DESIGN REVIEW TECHNICAL ADVISORY COMMITTEE MEETING

March 9, 2015

DESIGN REVIEW TECHNICAL ADVISORY COMMITTEE STAFF REPORT

Date: March 9, 2015
Applicant: Craig McCormick
Owner: Craig McCormick
Location: 219 16th Avenue SE
Request: Building Permit Review
Date Application Received: March 6, 2015

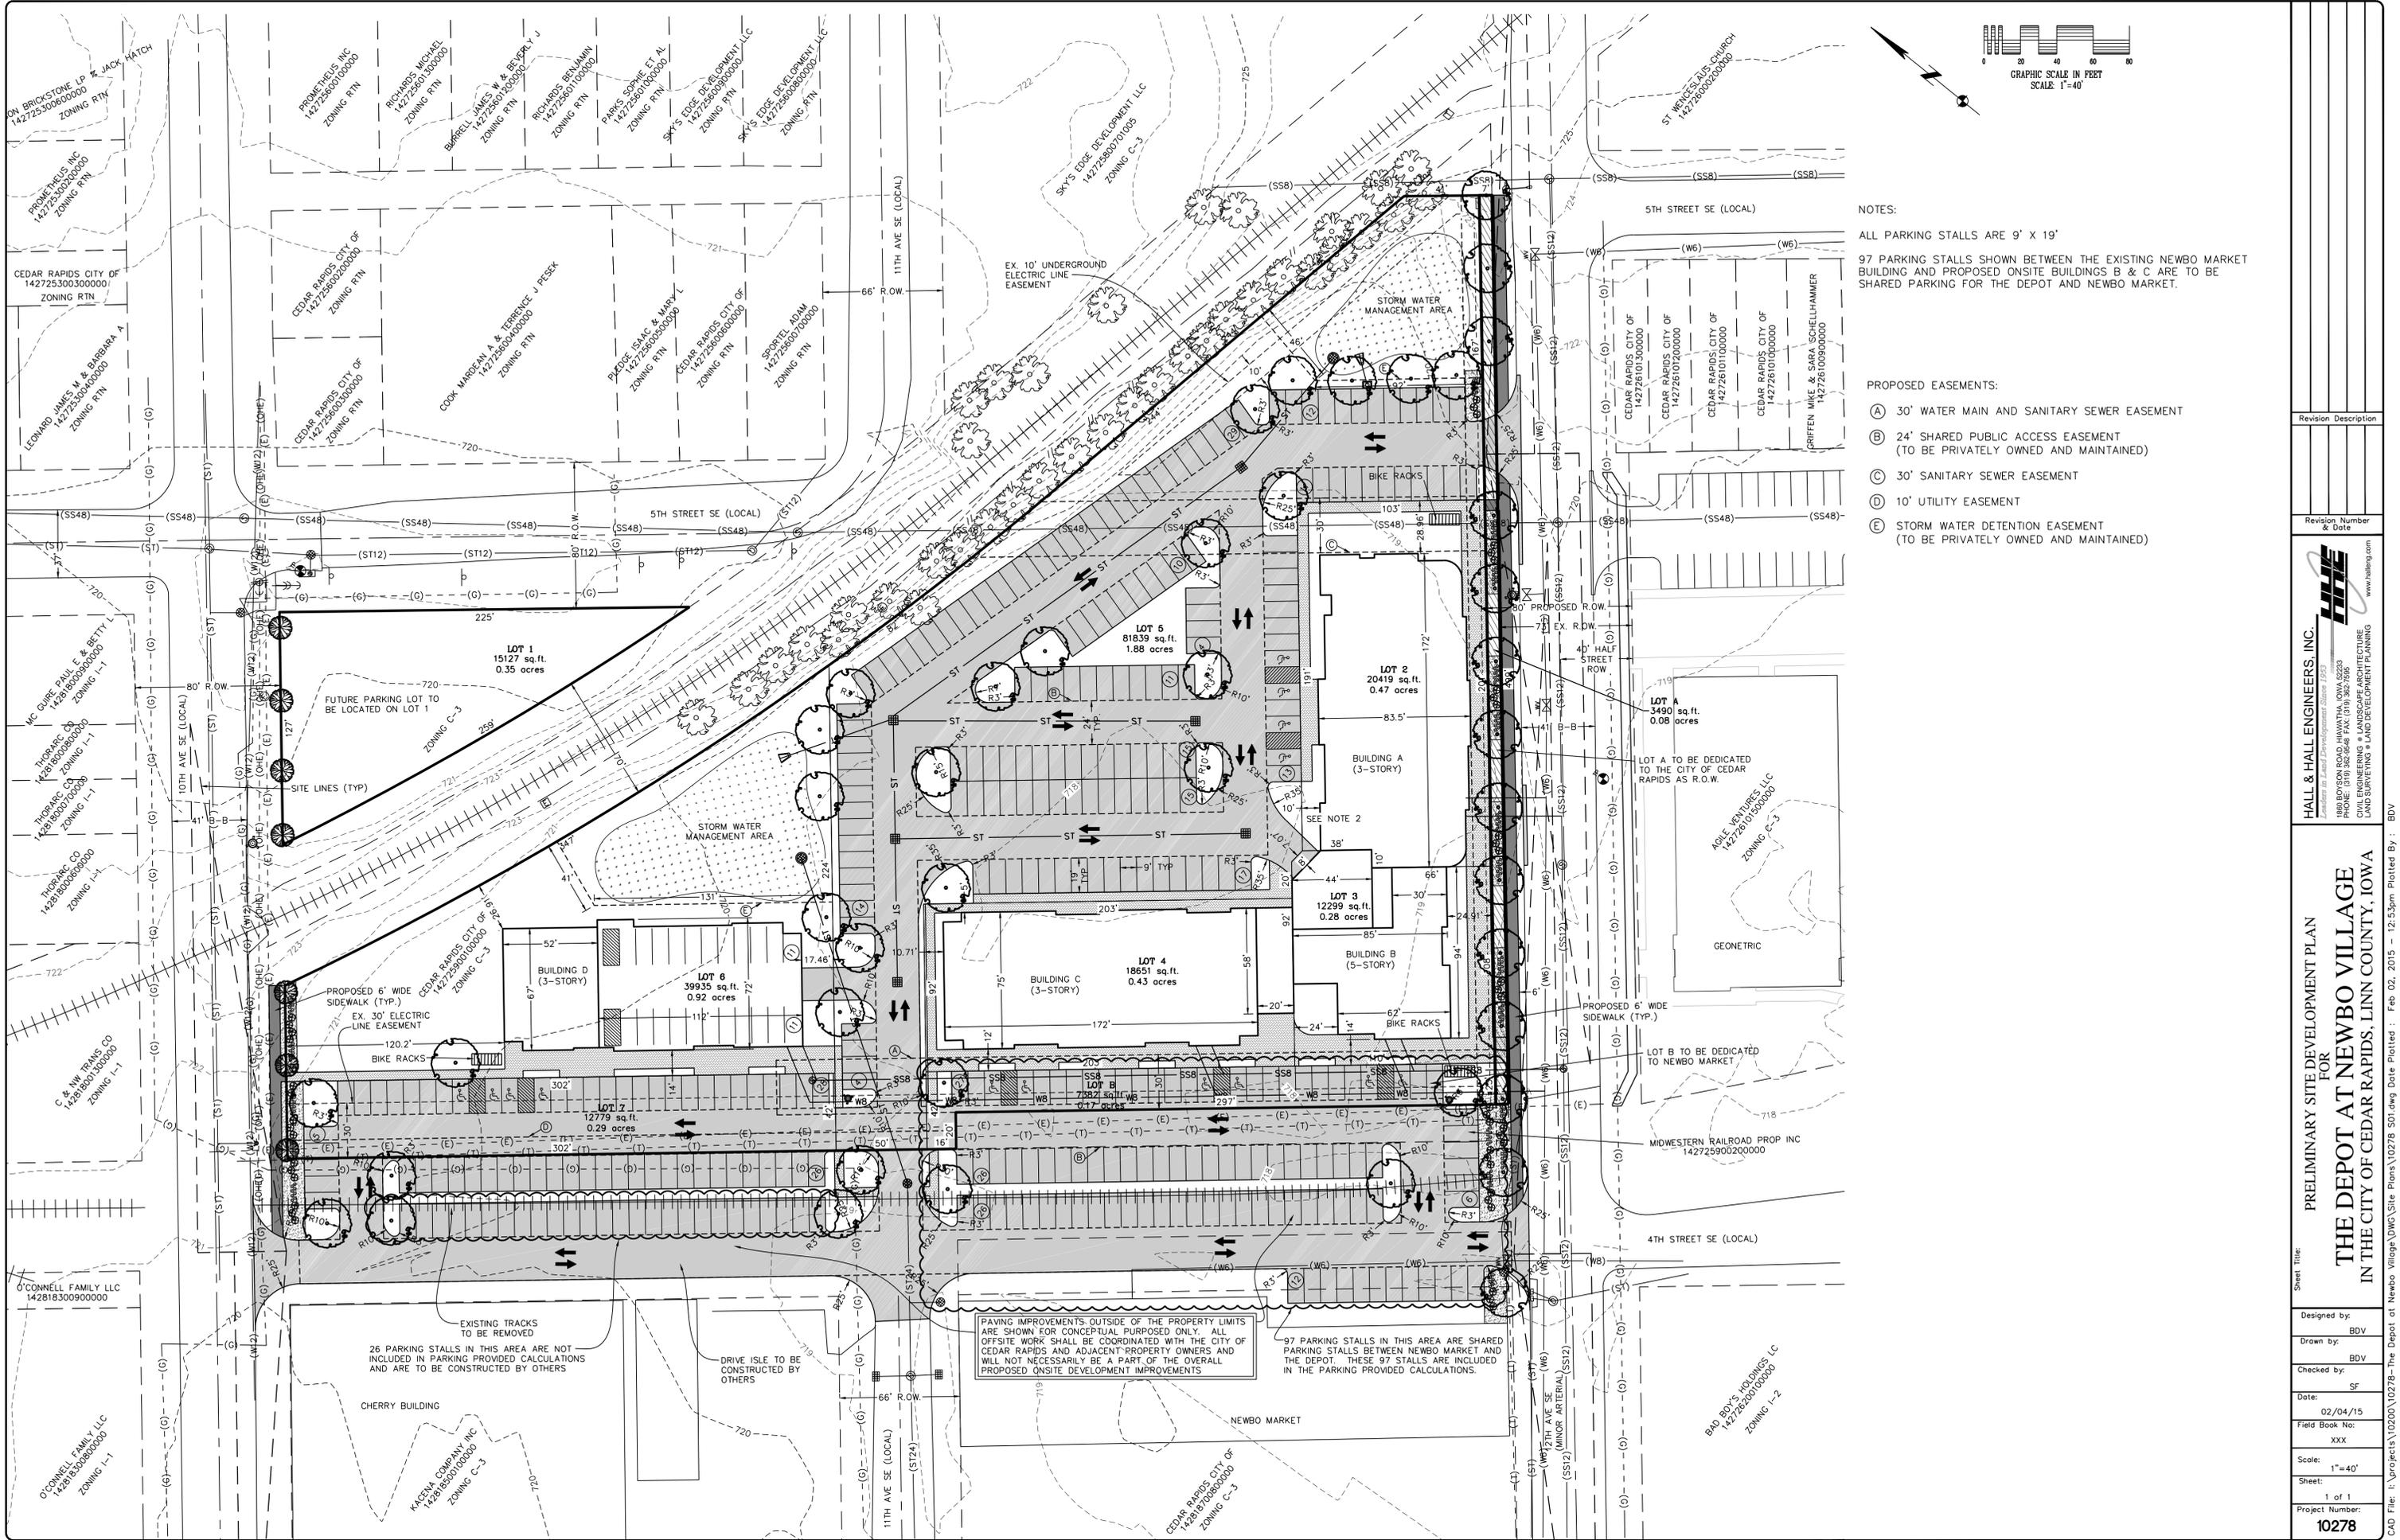
Standard	Meets Standard			Comments
	Y	N	N/A	
<i>Size, Form and Volume</i>				
1) Facade heights for new buildings and additions must fall within the height range of the surrounding block.	X			Project meets this standard. Phase 1 of the proposed project exceeds the height range of the surrounding block (5-story building).

4) Parking should be located behind buildings when feasible. Parking lots adjacent to sidewalks are discouraged.	X			Parking is located beside and behind the building.
<i>Architectural Details</i>

- No recommendations were provided by DRTAC
